**Rezoning from "Residential (Group C) 2" and "Open Space" zones to
"Residential (Group C) 4" zone for a Proposed Residential Development
at Lot Nos. 519 RP (part) and 520 RP in D.D. 110 and adjoining Government land,
Shek Kong, Yuen Long, N.T.**

**Rezoning from "Residential (Group C) 2" to "Open Space" zone
at Lot Nos. 121, 137, 138, 139 S.A and 139 RP (part) in D.D. 110
and adjoining Government land, Shek Kong, Yuen Long, N.T.
(S12A Amendment of Plan Application No. Y/YL-KTN/6)**

- Further Information No. 3 -

Comments Forwarded from Fanling, Sheung Shui and Yuen Long East District Planning Office (FSS&YLE DPO)

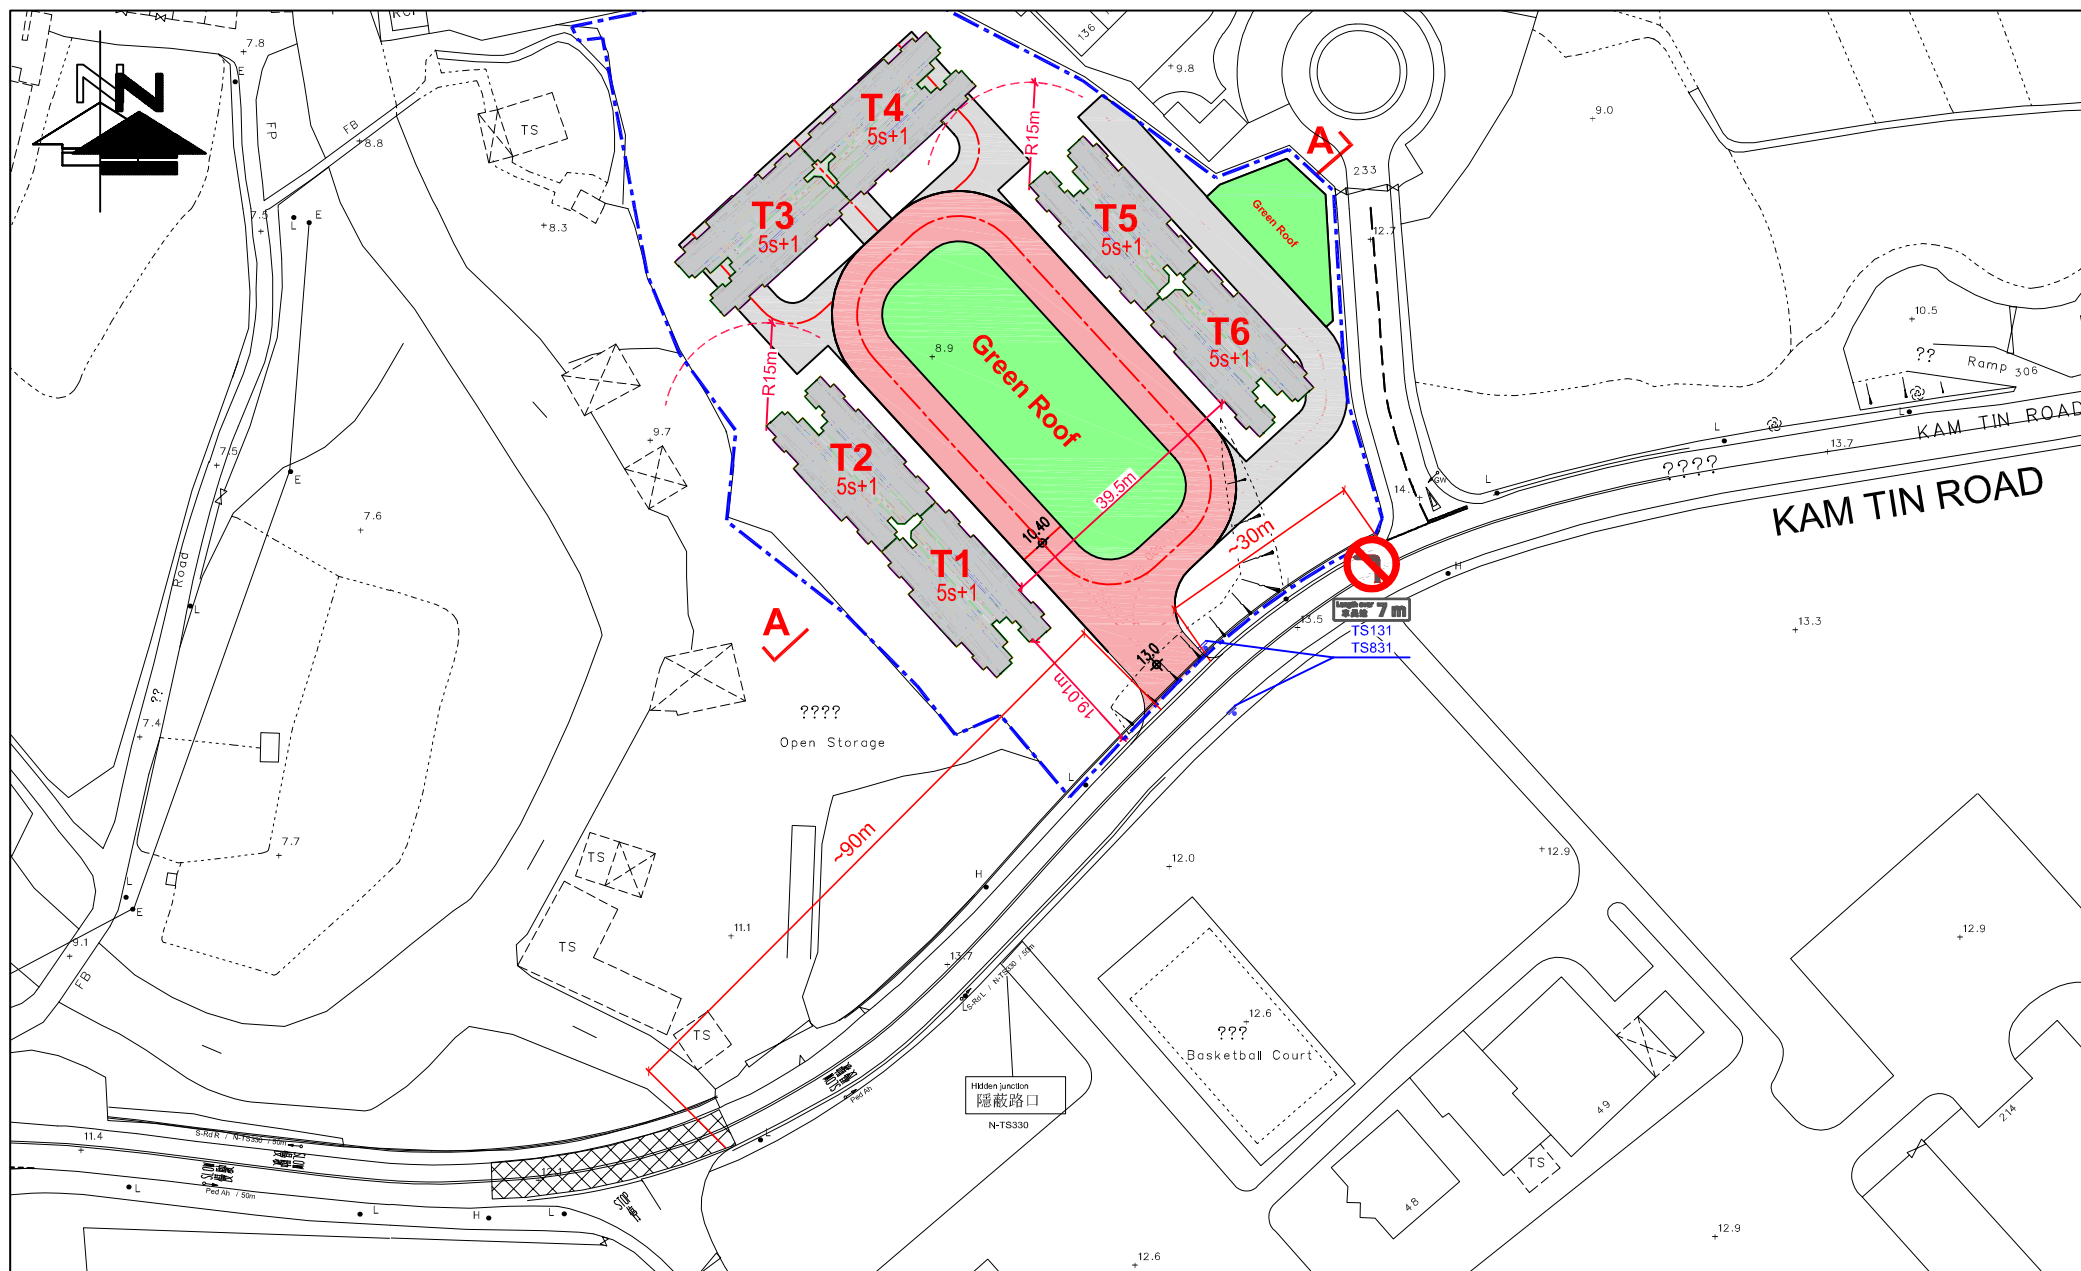
8. Figure 2.1 - the distance between the development run-in/out and the nearest junction shall be indicated. The applicant should also advise whether this could fulfill the requirement in TPDM.	The distance between the development run-in/out and the nearest junction (Kam Tin Road/ Avenue De Versailles) are shown in Figure 2.1 of the TIA report. The distance is min. 30m, which fulfills the requirement in TPDM.

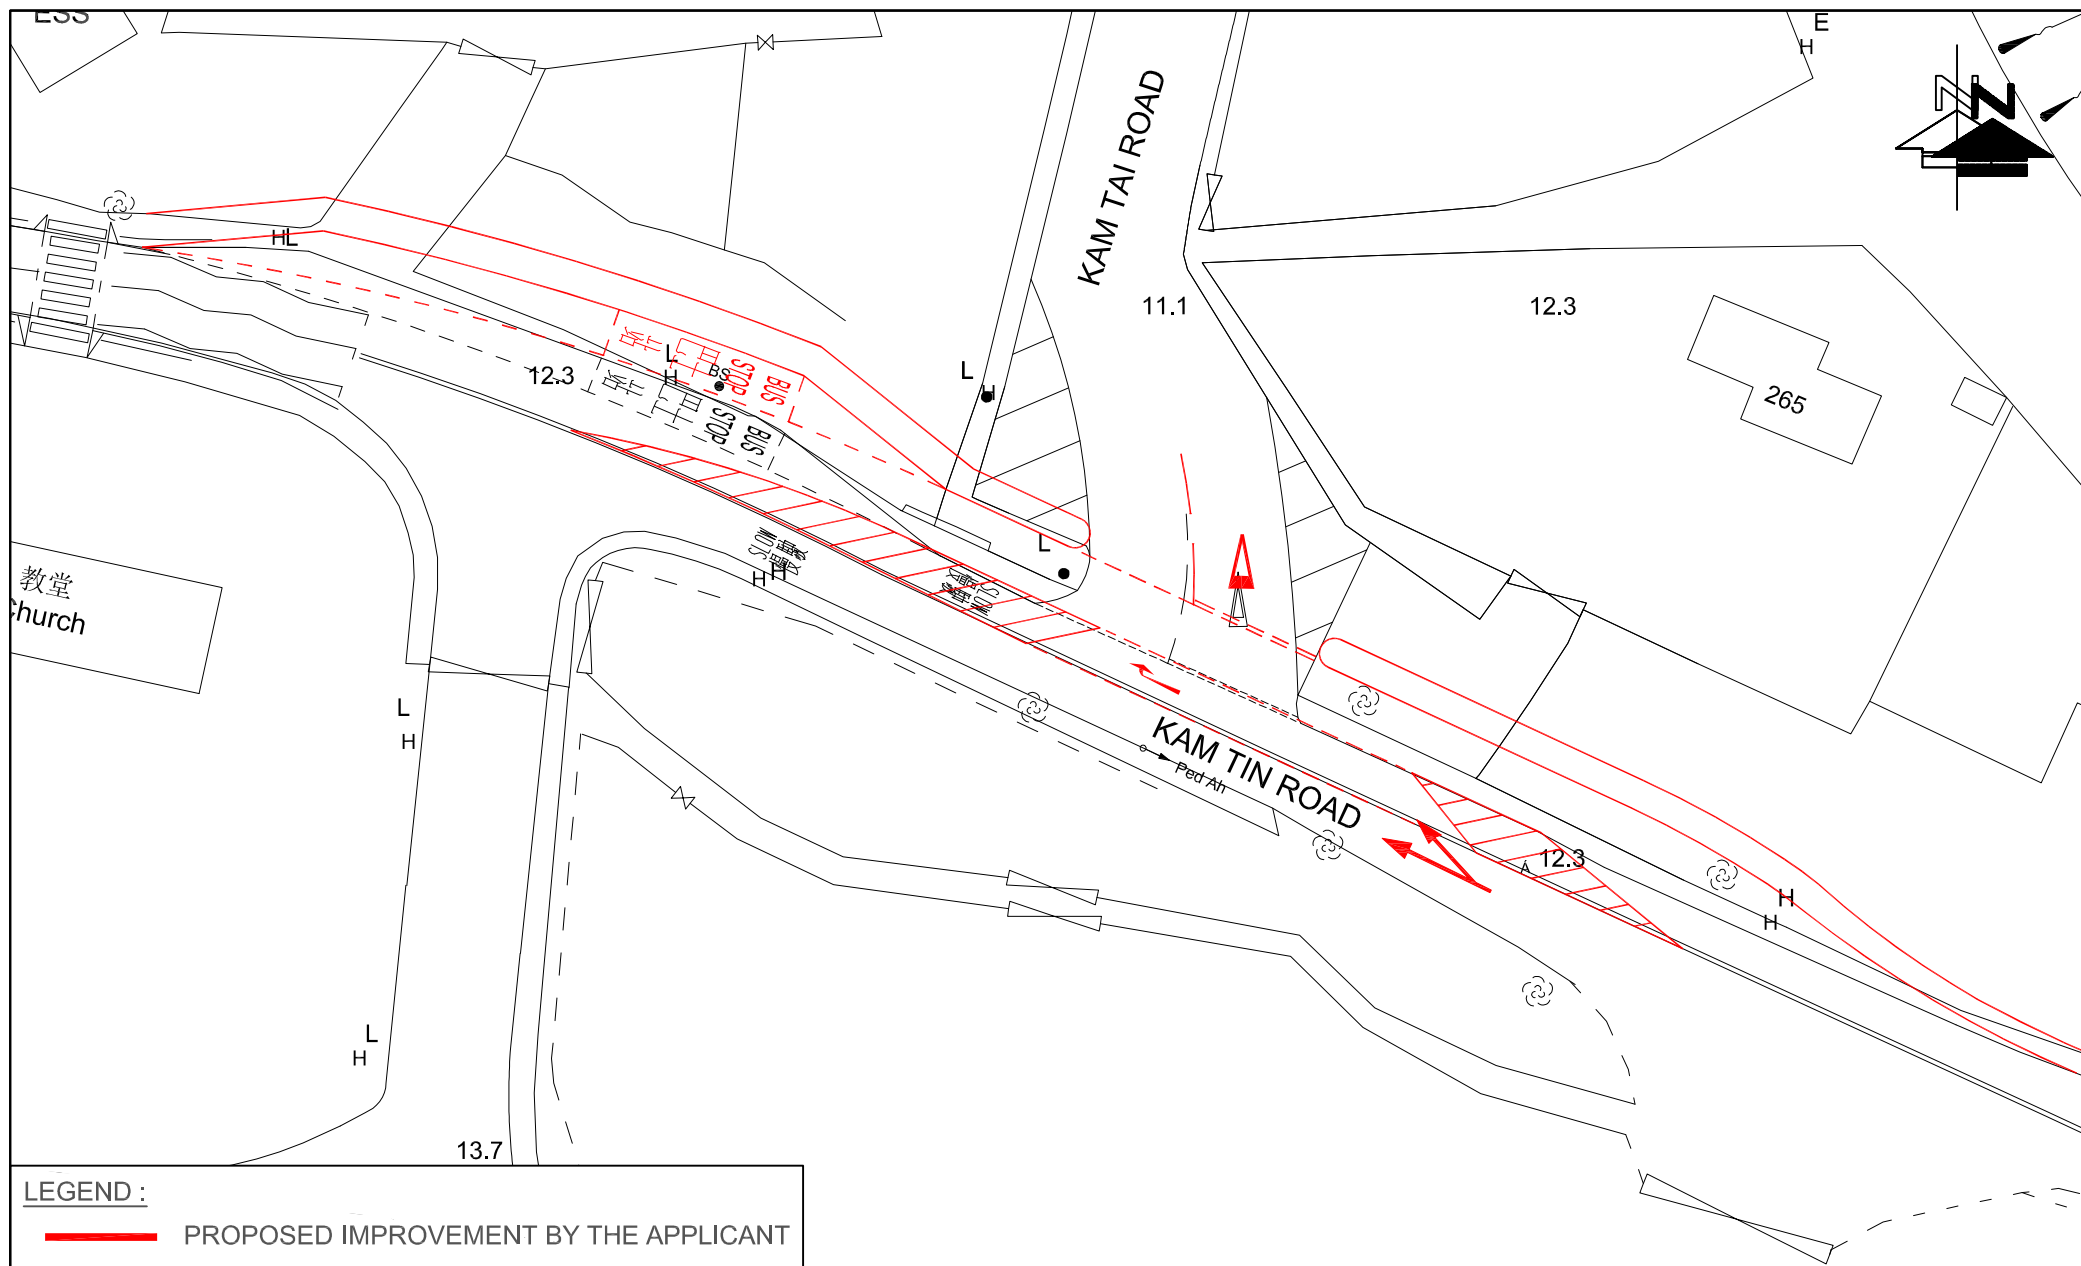
9. Figure 5.1 - in general the proposed improvement works ties in with the development, e.g. population intake, BC date etc, but not a public works. Please demonstrate when the improvement work would be carried out.	The improvement works will be carried out and completed before the population intake of the proposed development, in case of programme mis-match between the development and the public works project.
Comments from Environmental Protection Department (received on 25 February 2026) Contact person: Mr. Kelvin WONG; Tel. No.: 2835 1117	
It is understood from the RtC table that the consultant is waiting information from TD to address his previous comment (i.e. comment 2(ii) for the Air Quality Impact Assessment). As such, please update the report accordingly once information from TD has been received. Also, please delete the newly added sentence " <i>With reference to the lease of Seasons Villas (Lot 815 RP & Ext Thereto in DD110), this road is a non-exclusive right-of-way maintained by the owners of Seasons Villas.</i> " from S.7.1 of the report. Other than the above, we have no further comment.	As per verbal conversation and written reply by TD, Avenue de Versailles is not under TD's management and thus TD consider not in position to comment on its road type. Since Avenue de Versailles connects to Season Villas only, according to Volume 2 Chapter 3.2 of Transport Planning and Design Manual (TPDM) published by TD, it is regarded as a feeder road. Based on the Annual Traffic Census 2024 (ATC) published by TD, Kam Tin Road (ATC Station no.6207) is Rural Road. TD has no comment on the road type of Kam Tin Road.

5.3.3 For Junction C, an improvement scheme is proposed as shown in **Figure 5.1**. The Applicant considers carrying out the improvement works as per the improvement scheme, in case of programme mis-match between the development and the public works project.

Proposed Drainage System

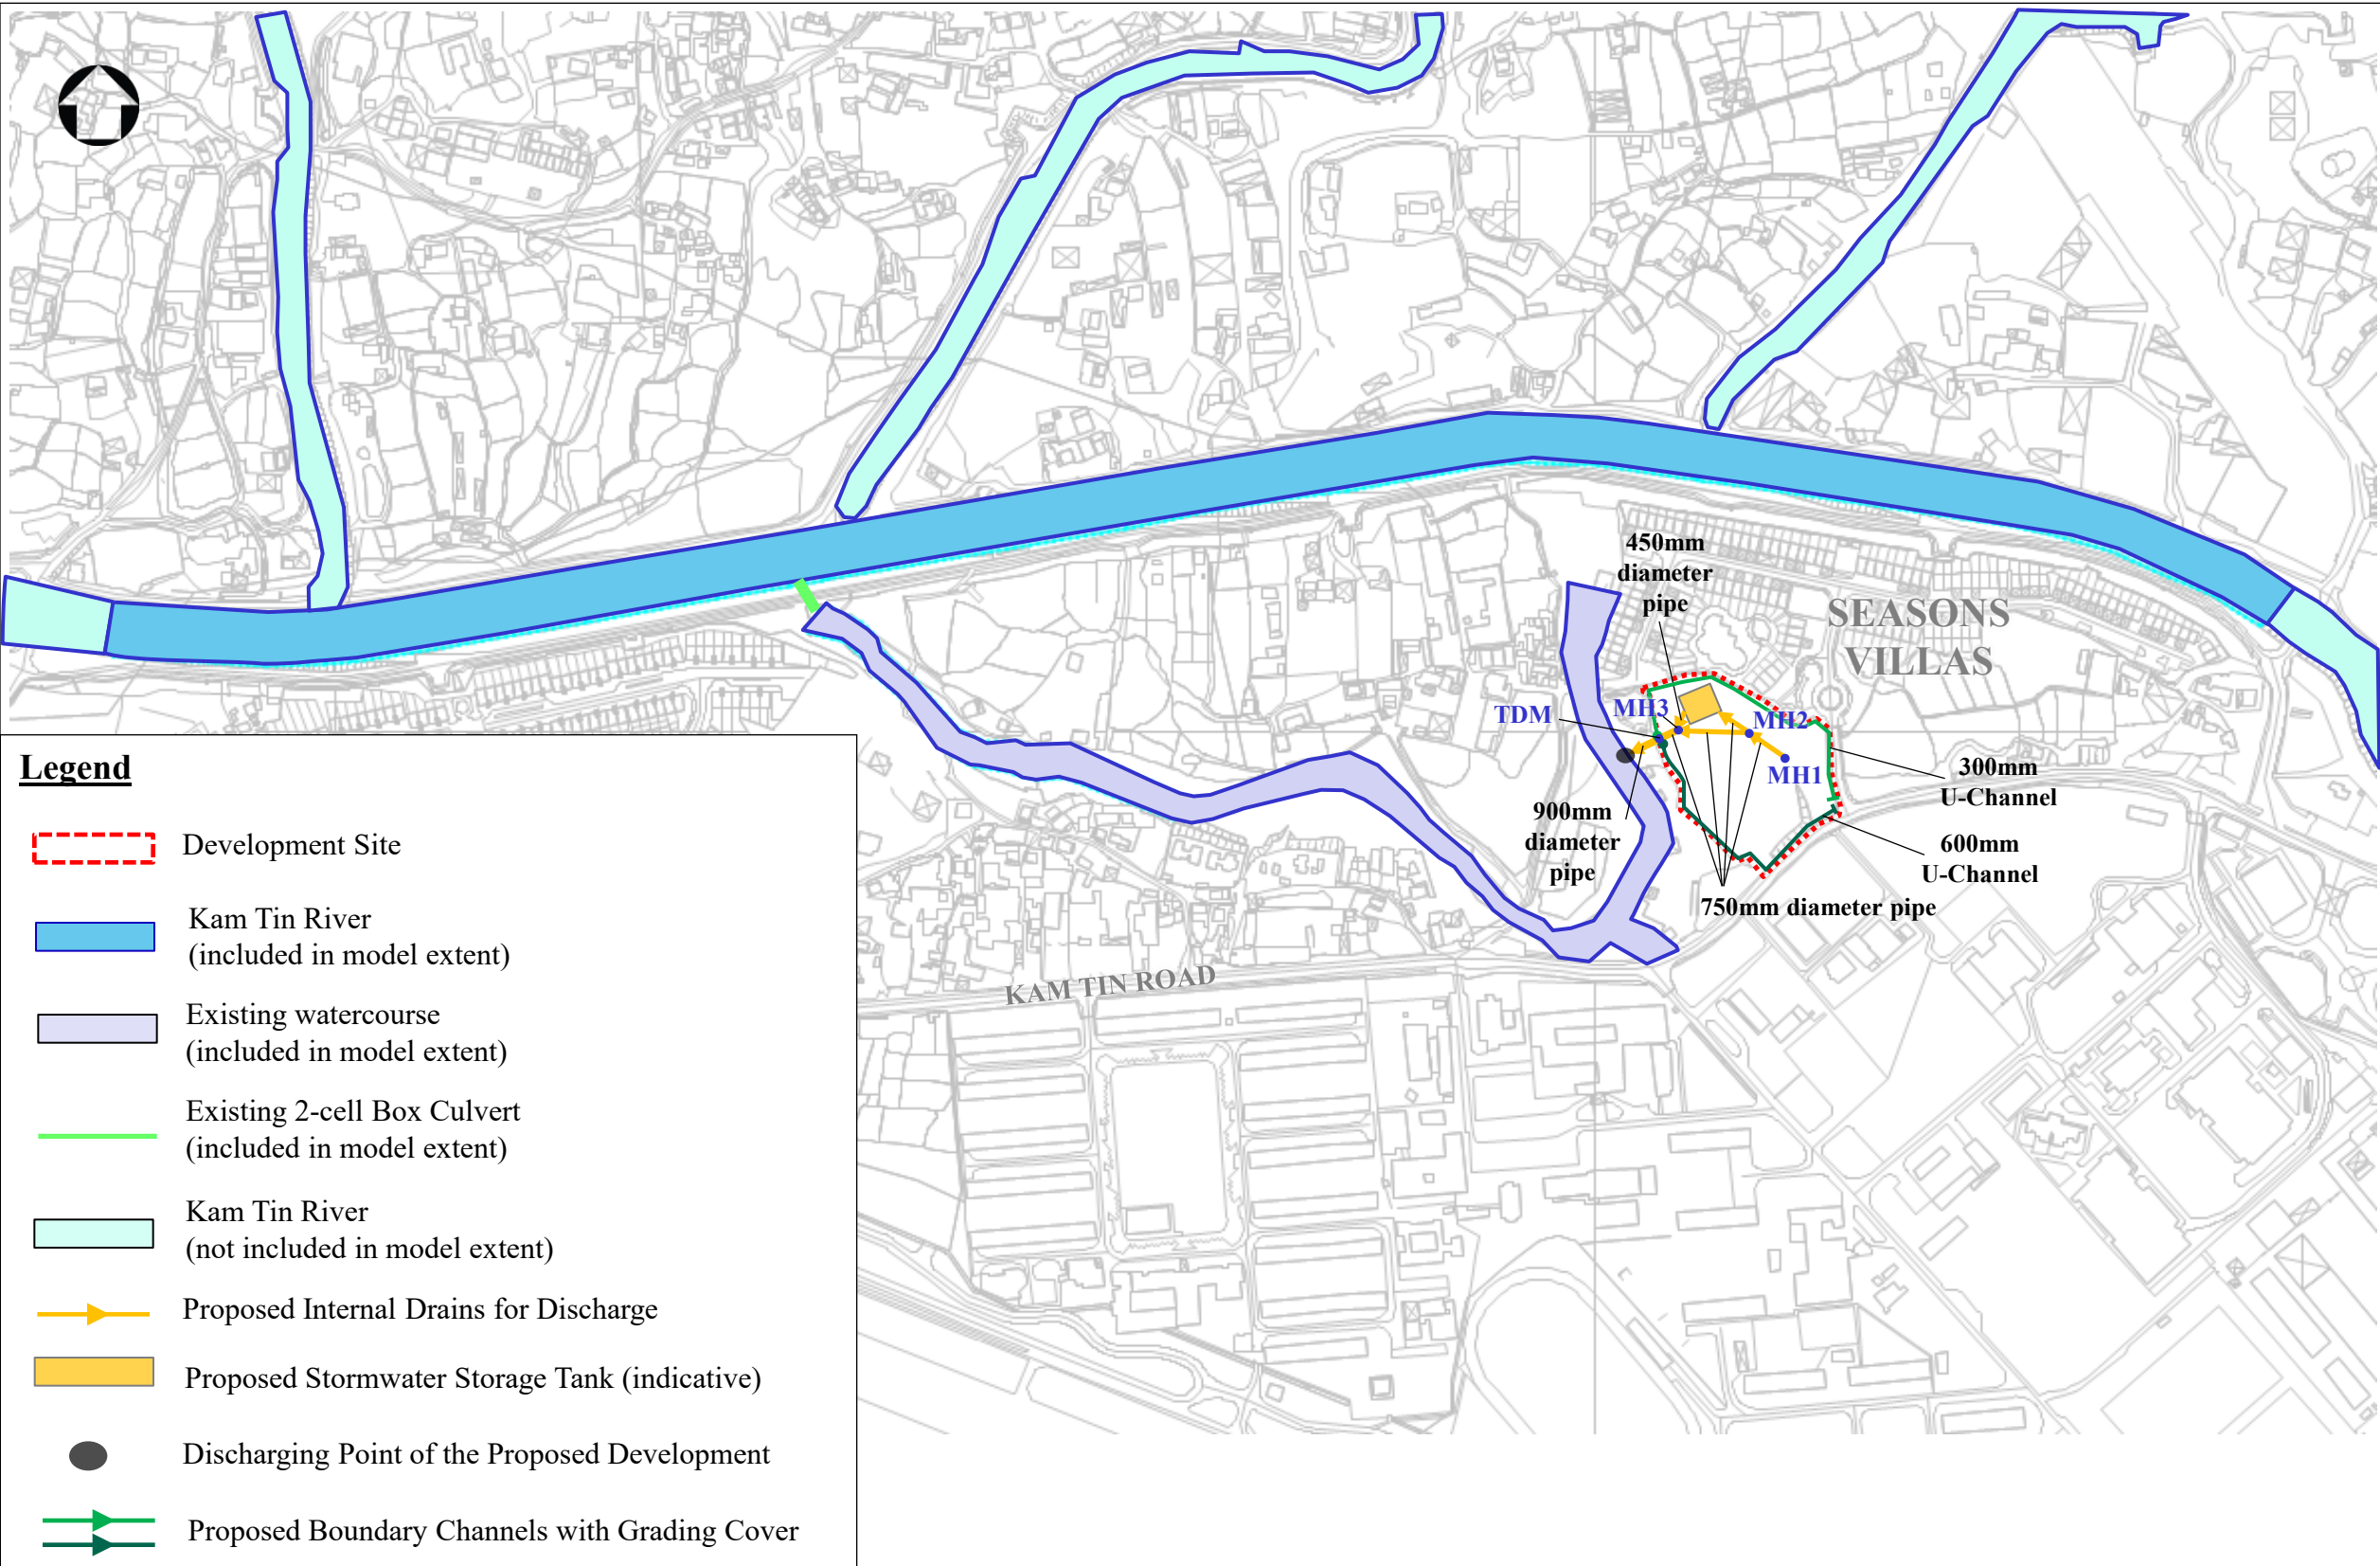
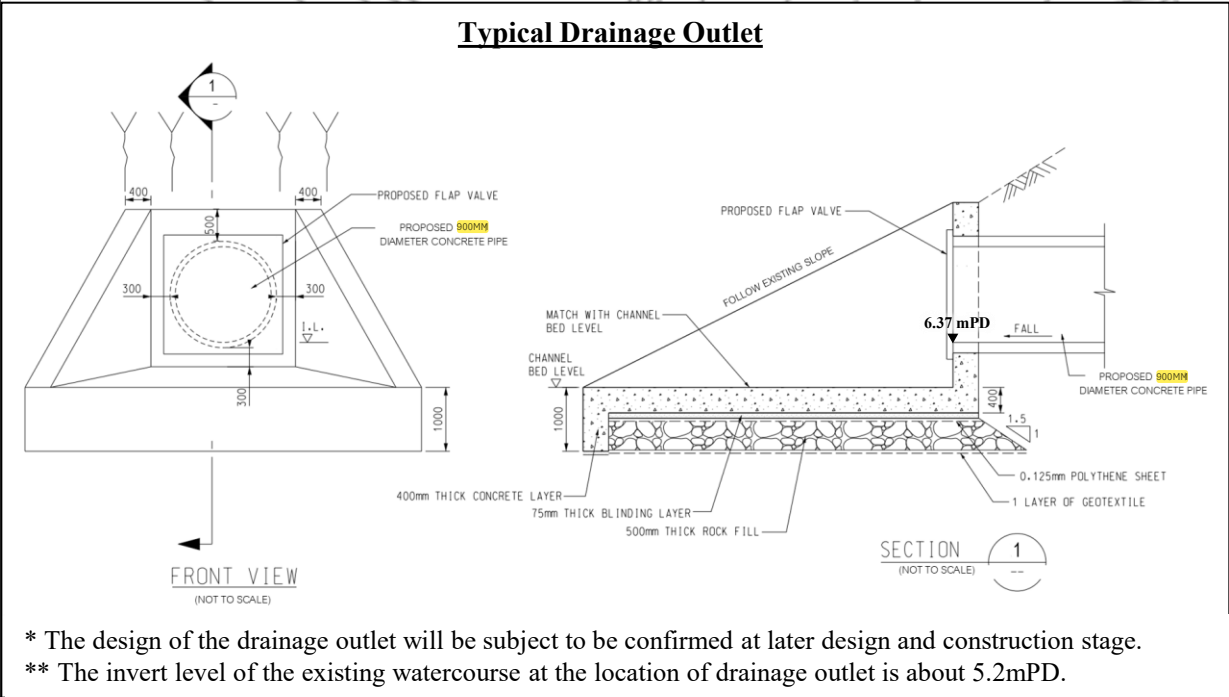
2. The applicant should clarify discrepancy of invert levels of the proposed 300 mm and 600 mm dia. stormwater drainage pipes shown on the submitted drainage plan and pipe schedule. The applicant should update the submitted hydraulic calculation in Appendix I.	The invert levels of the proposed 300 mm and 600 mm dia. stormwater drainage pipes are revised in Appendix B2 . Appendix I is updated to include the hydraulic calculation of the proposed 300mm pipe.

3. The applicant should clarify size of the proposed stormwater pipe shown in the proposed connection details of existing watercourse and the proposed stormwater terminal manhole TDM	The proposed stormwater pipe connecting the proposed stormwater terminal manhole is 900mm diameter. The pipe sizes shown in the typical drainage outlet in Appendix B2 are updated.

5. The DTL of the proposed stormwater terminal manhole should be indicated on the drawing complying with the current Government standard and a 150mm difference between I.L. and D.T.I.L. should be maintained.	The proposed stormwater terminal manhole will comply with the current Government standard and have a 150mm difference between I.L and D.T.I.L of the proposed stormwater terminal manhole (i.e. TDM in Appendix B2). The invert levels of the incoming pipes of TDM are 6.75mPD for proposed 300mm pipe, 6.73mPD for proposed 600mm pipe and 6.675mPD for proposed 750mm. The D.T.I.L of the outgoing pipe of TDM has been set at 6.525mPD, providing the required 150 mm difference between the lowest I.L. (6.675mPD) and the D.T.I.L. (6.525mPD). The information has been provided in Appendix B2.
